ADDENDUM NO. 1

September 1, 2022

CROWN POINT HIGH SCHOOL ATHLETIC FIELDS AND SITE IMPROVEMENTS
Crown Point, IN 46307

SHEET
S-108

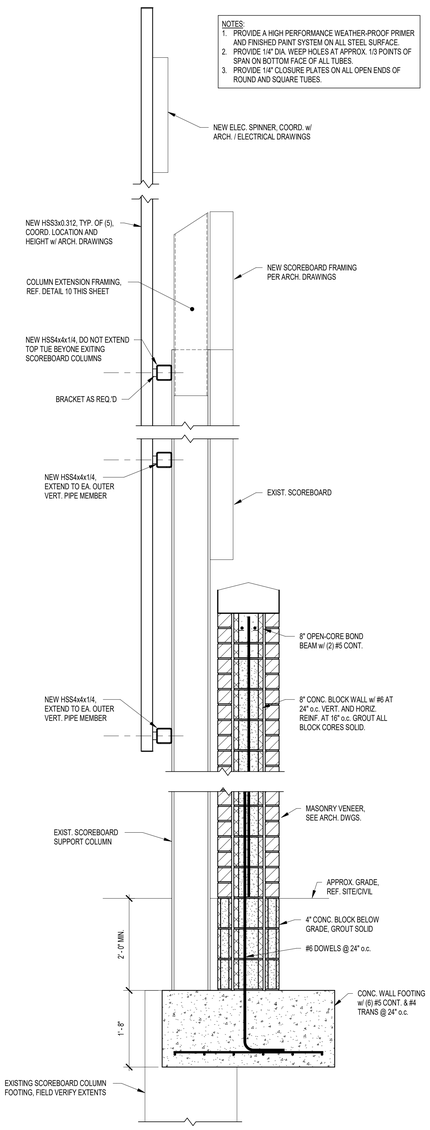
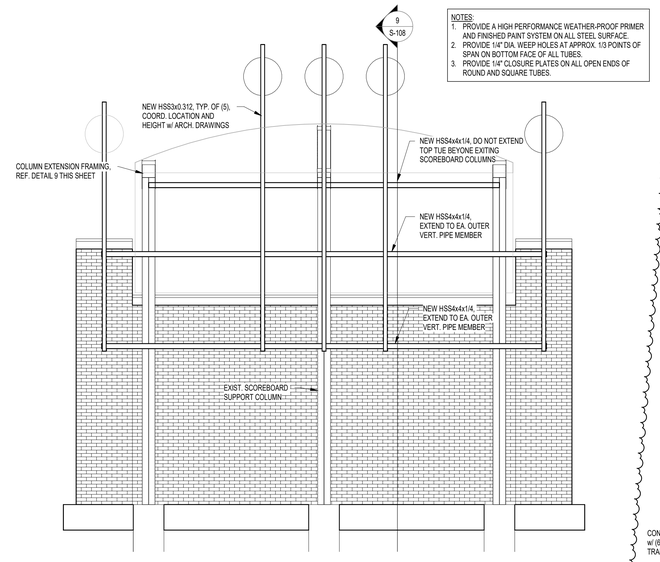
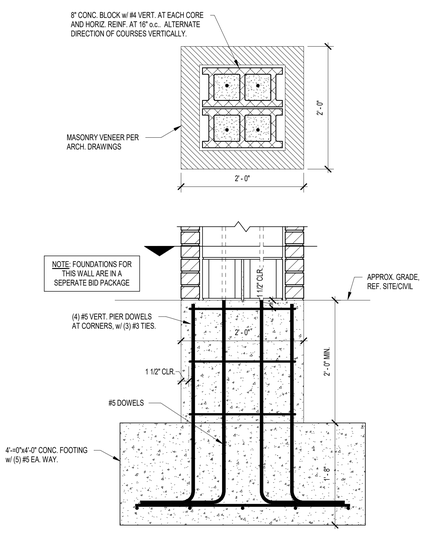
1. Baseball scoreboard structural plan added, along with associated details.
2. Masonry pier with concrete base detail added.

SHEET
A-106

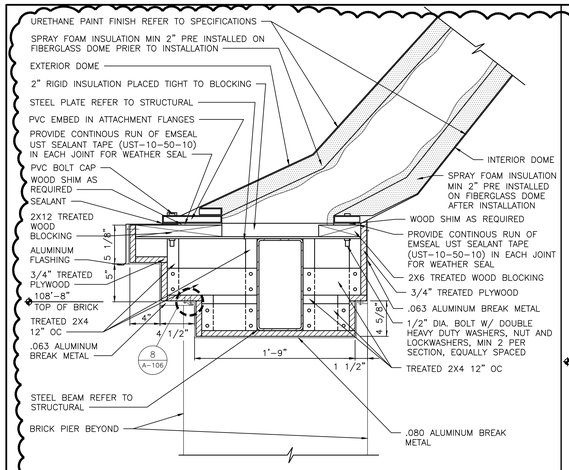
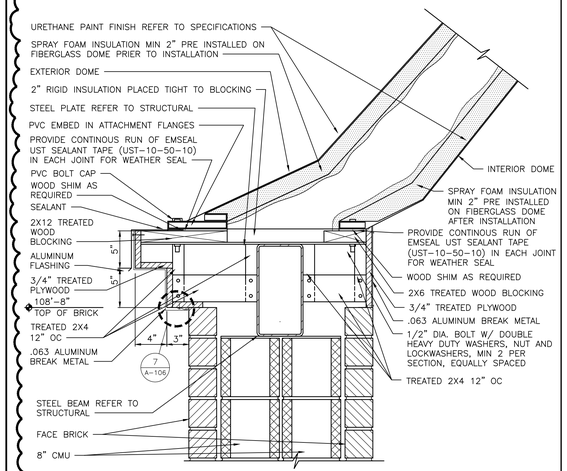
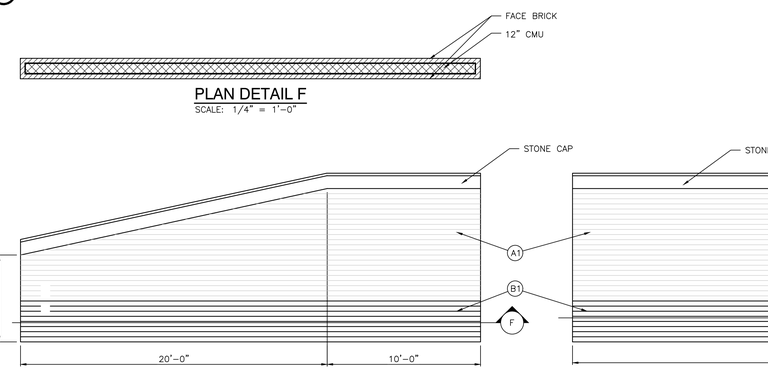
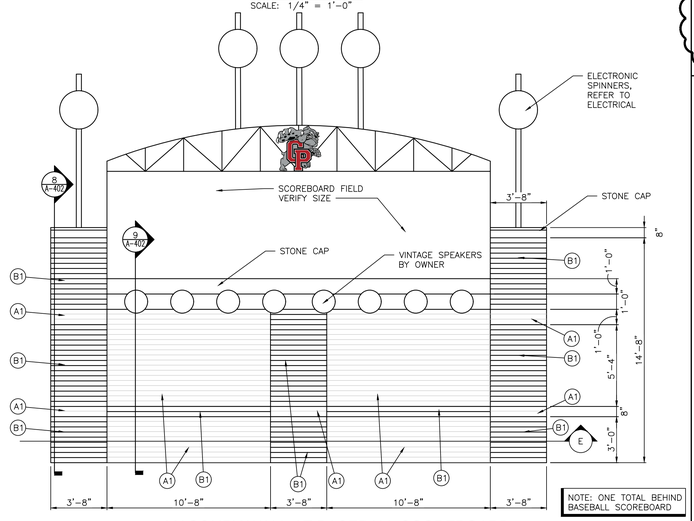
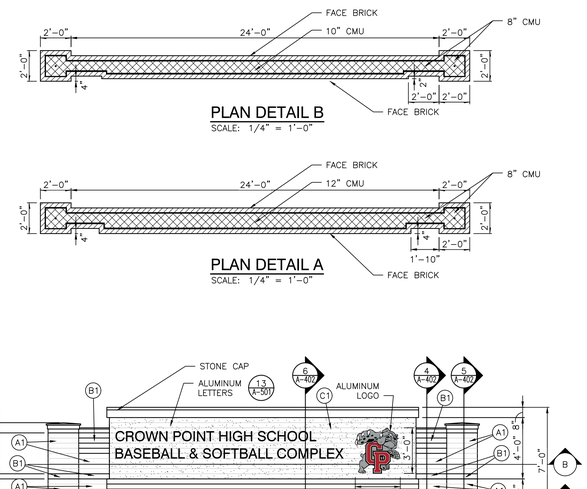
1. Revise 3/A-106 plan and elevation.
2. Add section 9/A-106 and details 7,8,10,11/A-106.

MECHANICAL HVAC PLAN

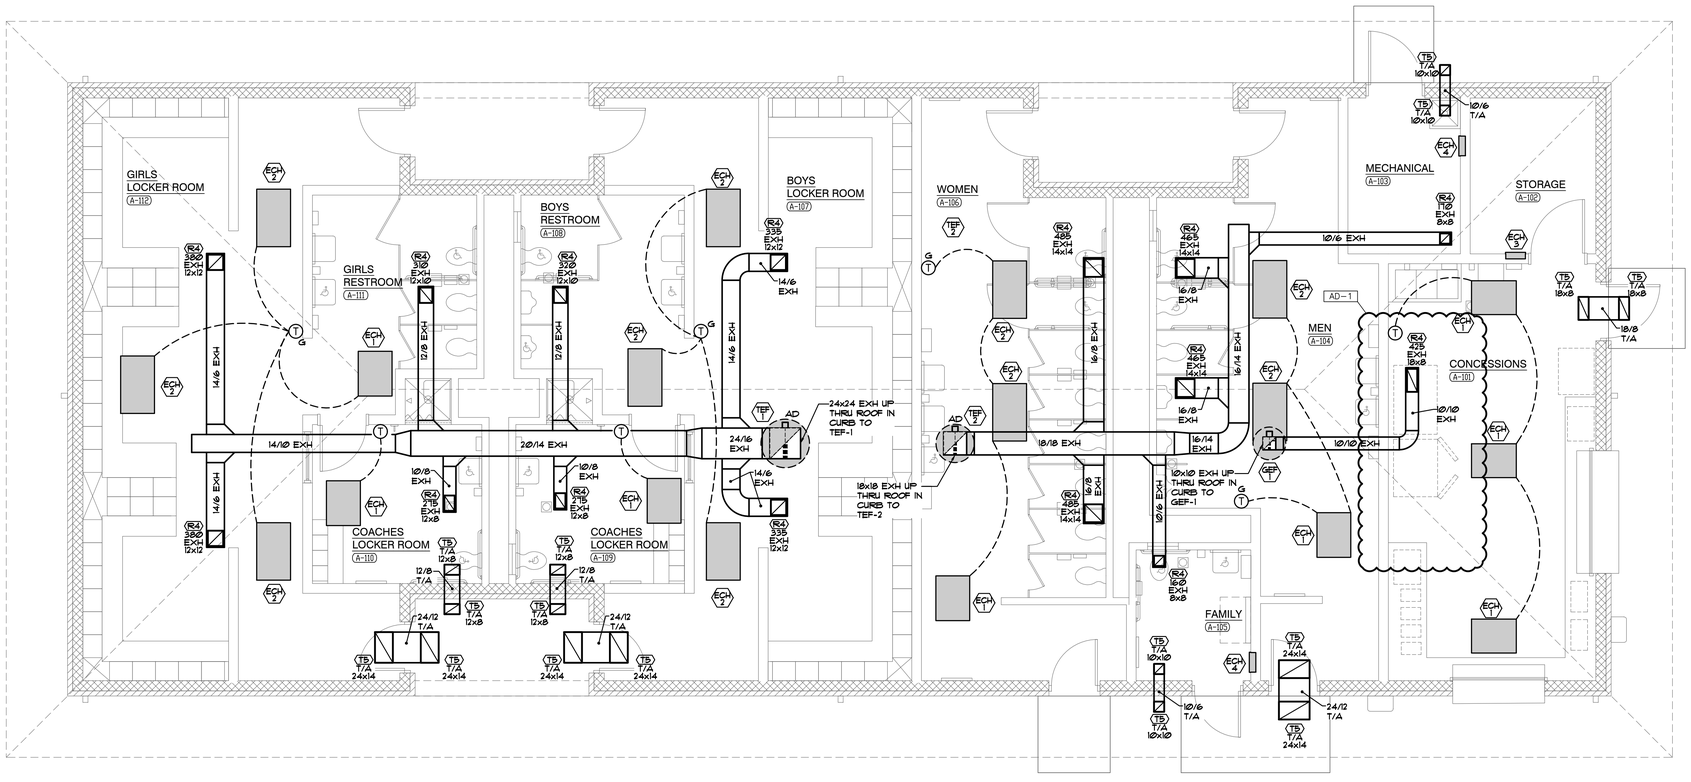
A. Refer to revised, full-size drawing, included in this Addendum, for revised location of exhaust grill in Concessions A-101.

RISER DIAGRAM

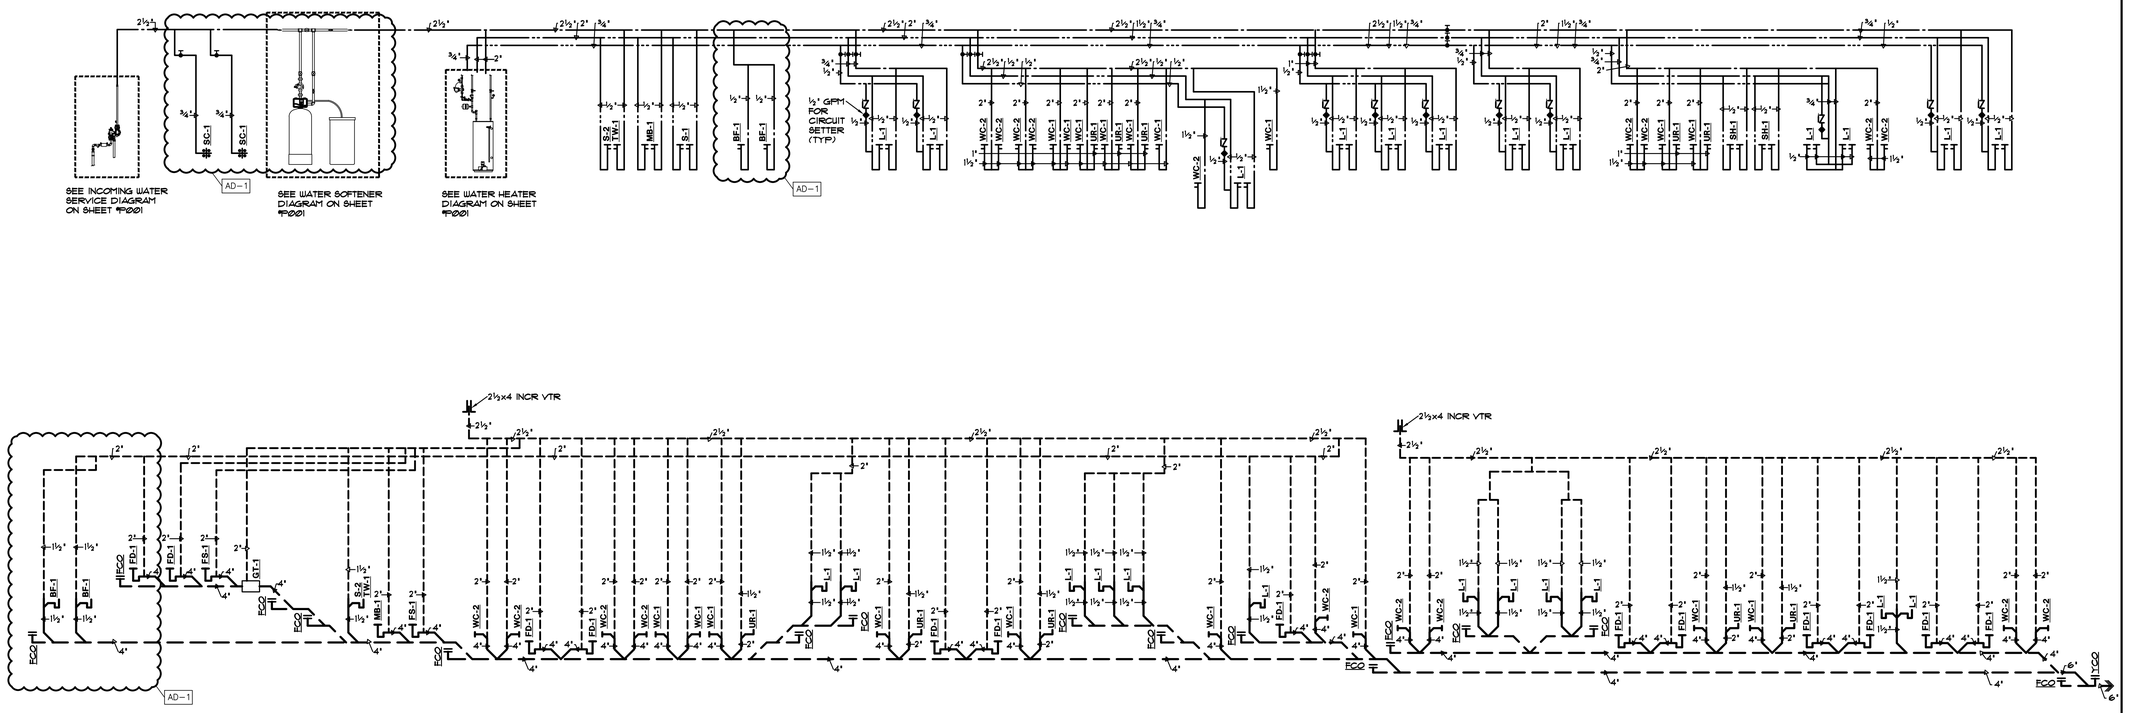
1. Revised Riser Diagram to add bottle filer.
2. Revised location of SC-1.

PLUMBING FLOOR PLAN
SCALE: 1/4" = 1'-0"

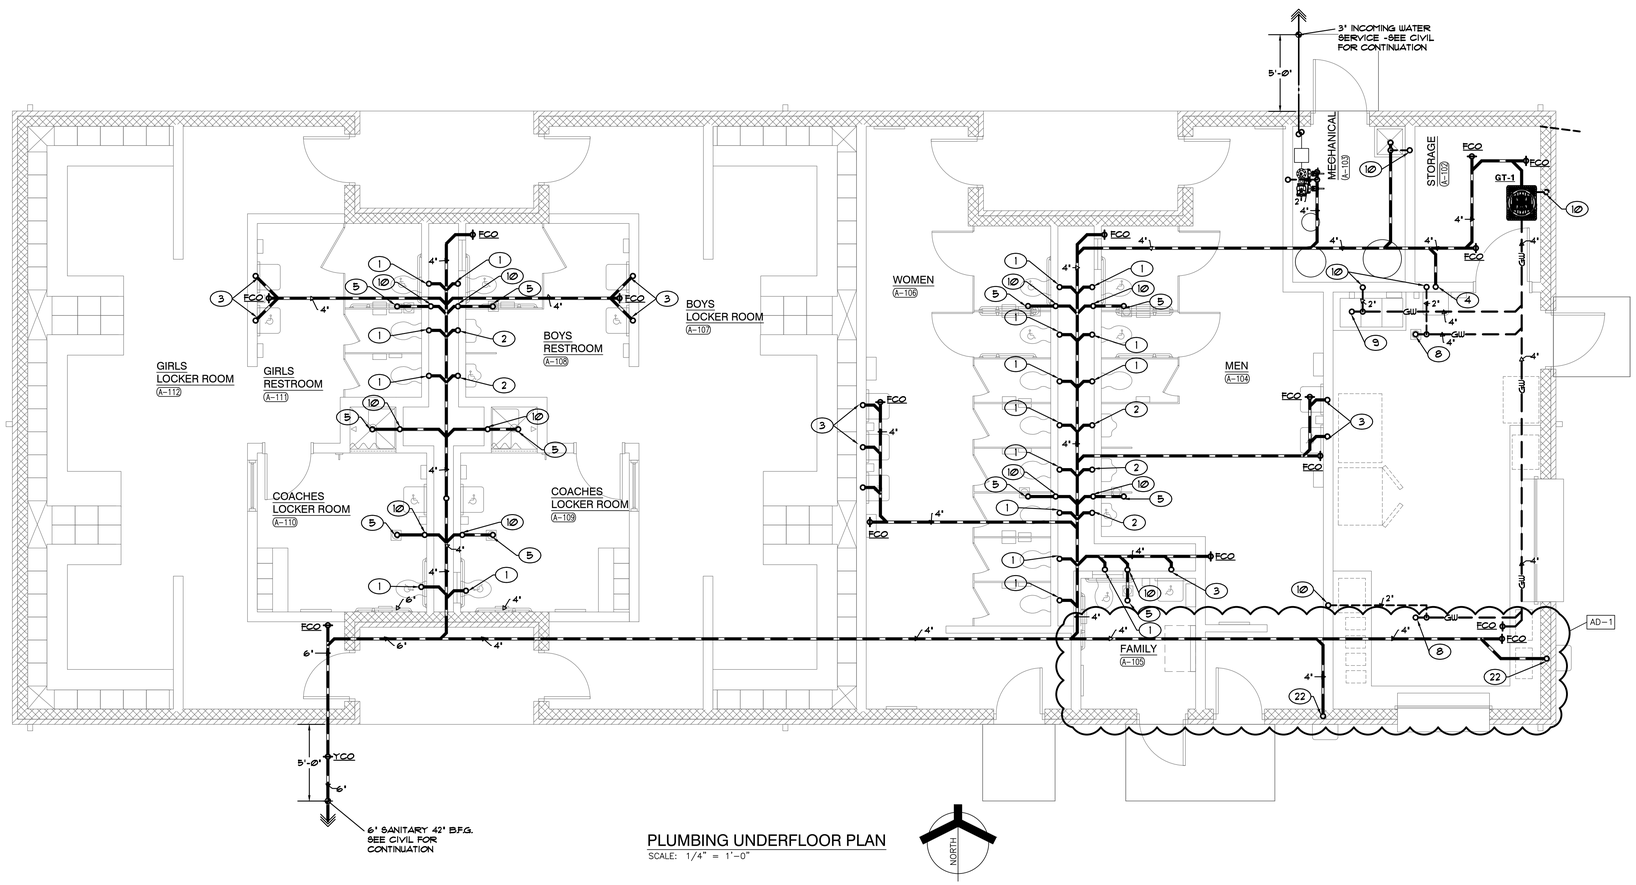
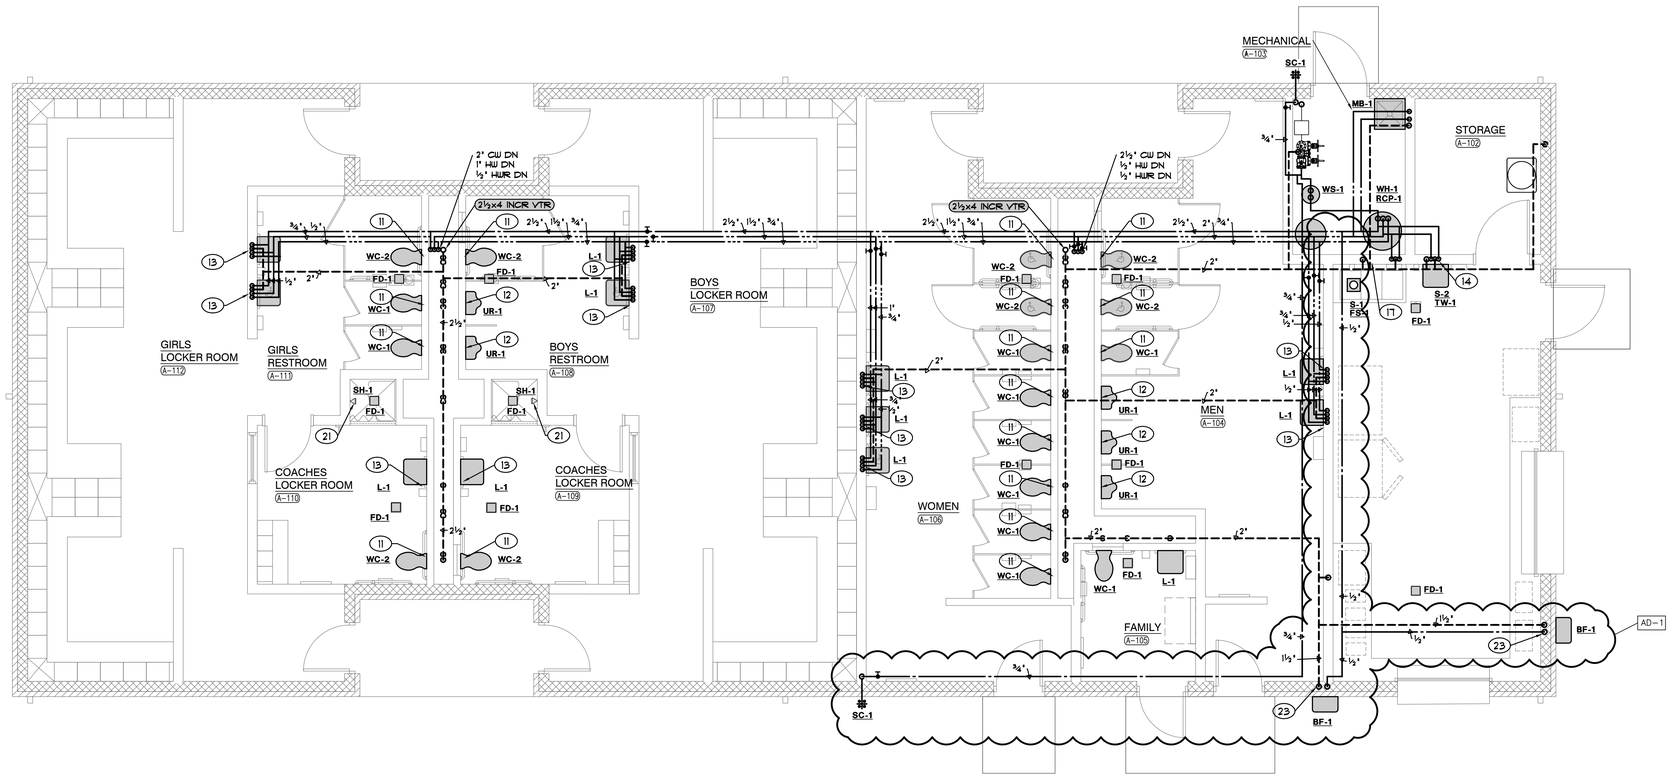
1. Revised location of SC-1.
2. Added two bottle fillers.

7 ELECTRICAL LIGHTING TENNIS PLATFORM PLAN
SCALE: 1/4" = 1'-0"

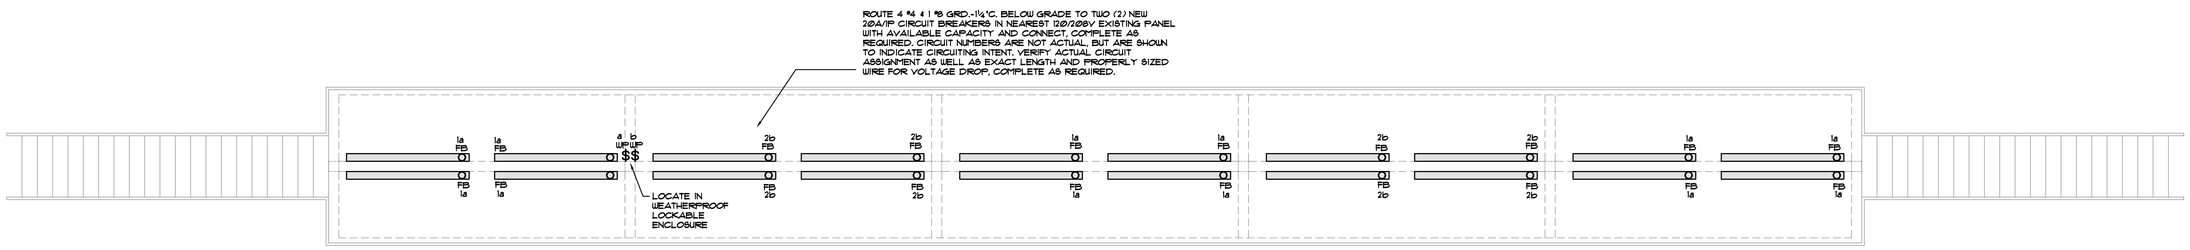
1. Revised ticket booth lighting to utilize type WA wall sconces.

ELECTRICAL POWER PLAN
SCALE: 1/4" = 1'-0"

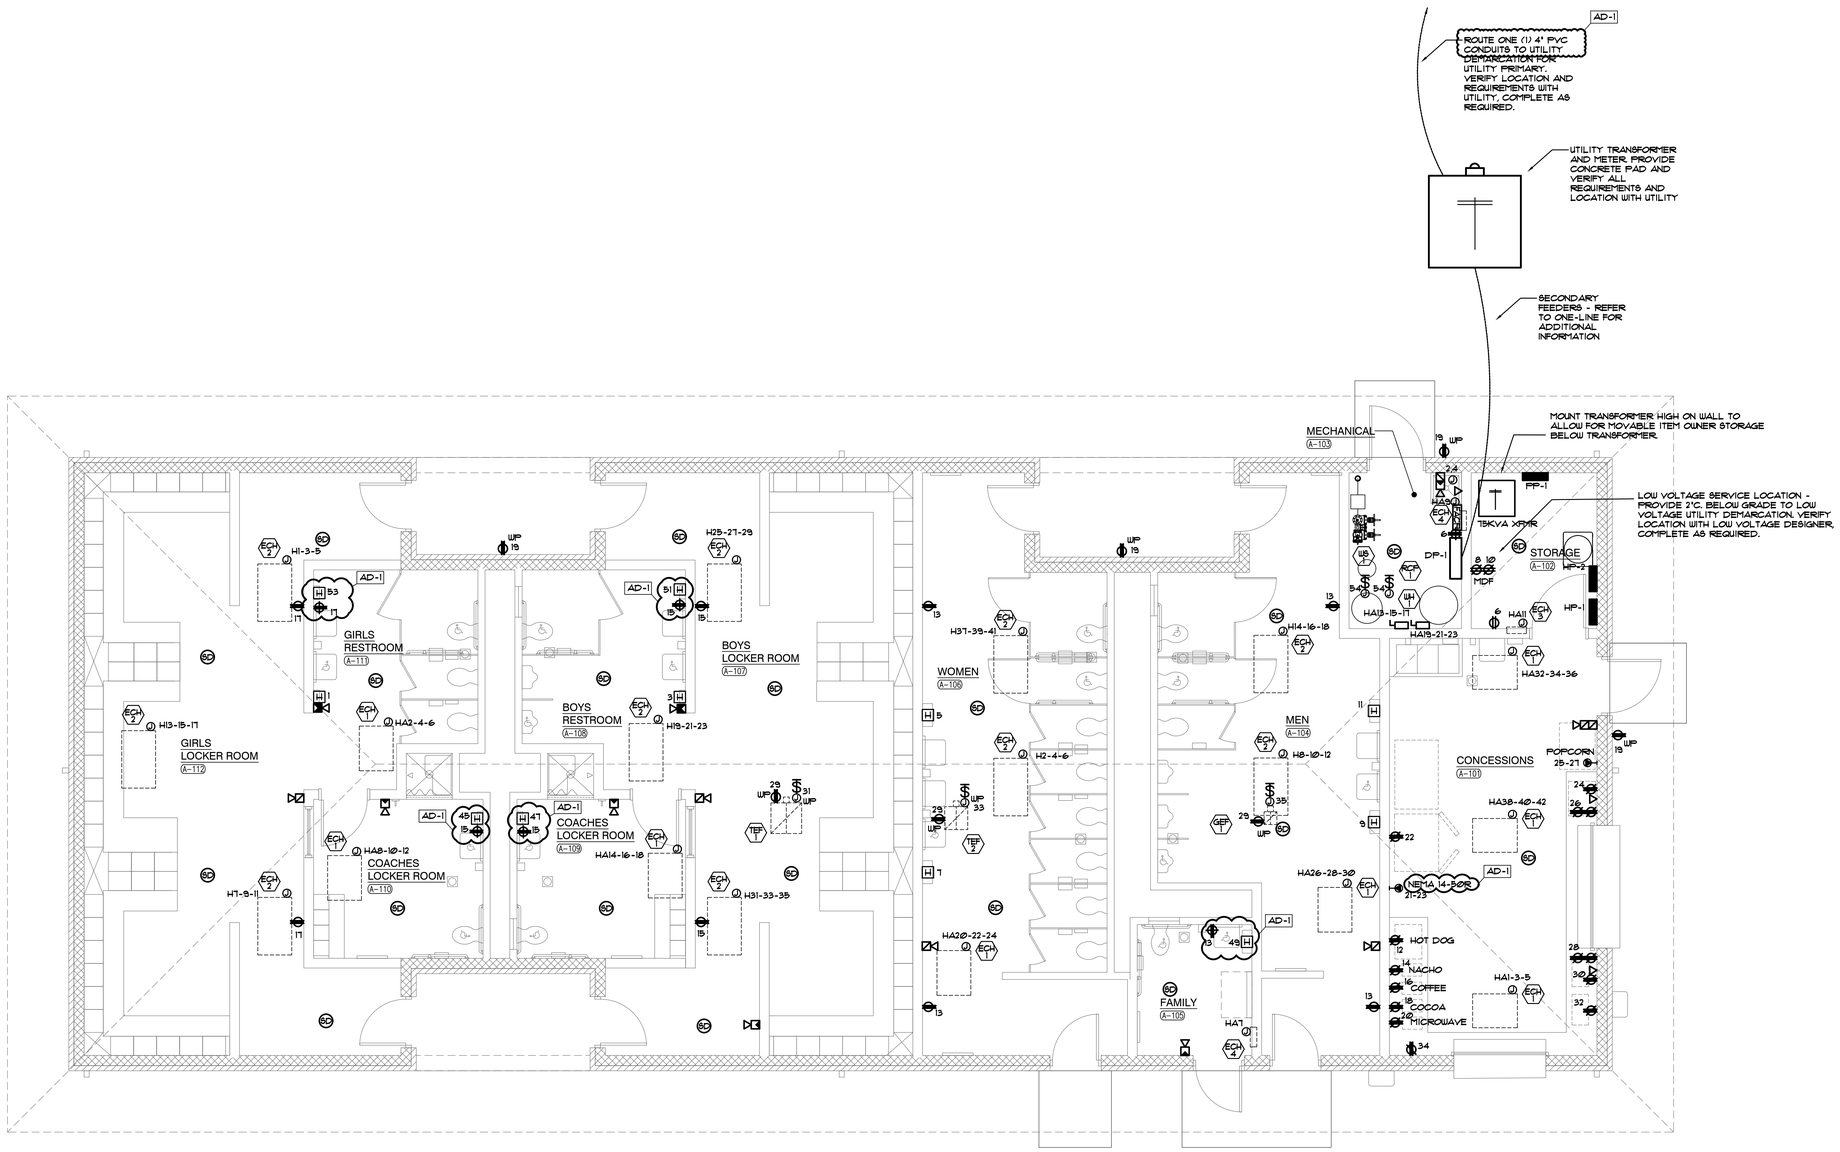
1. Revised number of conduits for the utility primary.
2. Added additional hand dryer locations.
